Amendments to the Drawings:

REMARKS

Fig. 3
(Prior Art)

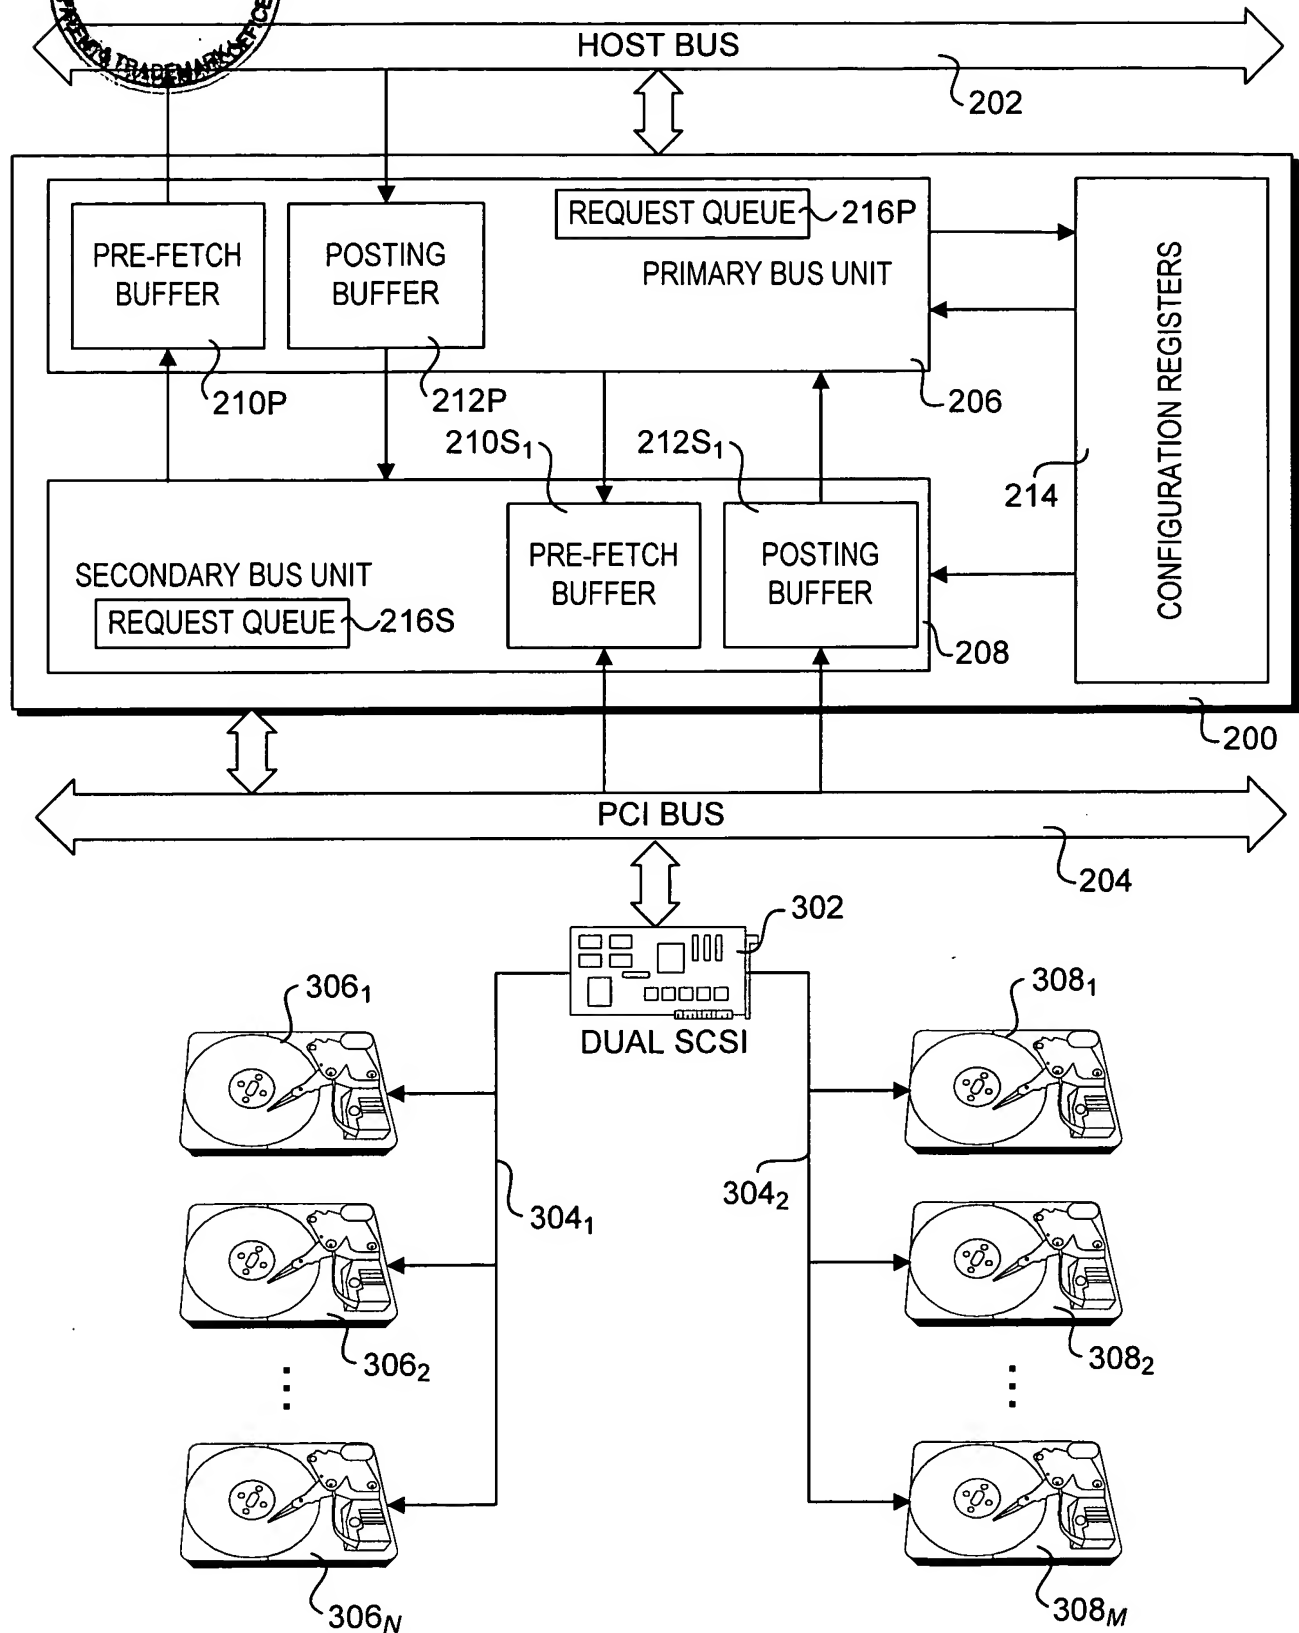
The drawings stand objected to because Figures 2, 3, and 3A should be designated by a legend such as --Prior Art--. In particular, the Office Action states that because only that which is old is illustrated. Applicant respectfully submits that Figures 2, 3, and 3A have been amended to include a legend, --Prior Art-- as suggested by the Examiner. Applicant appreciates the Examiner's recommendation and respectfully requests that the objection to the drawings be withdrawn.

The attached drawing sheet(s) include changes to Figure(s) 2, 3, and 3A. In Figures 2, 3, and 3A, --Prior Art-- has been added to identify that which is old. In Figure 4, reference numbers 407 and 410 have been added to identify the data transfer 410, and virtual pre-fetch buffer 407, as described at least in the specification at paragraphs [0053-0055]. Similarly, in Figure 5, reference number 407 has been added to identify the virtual pre-fetch buffer 407.
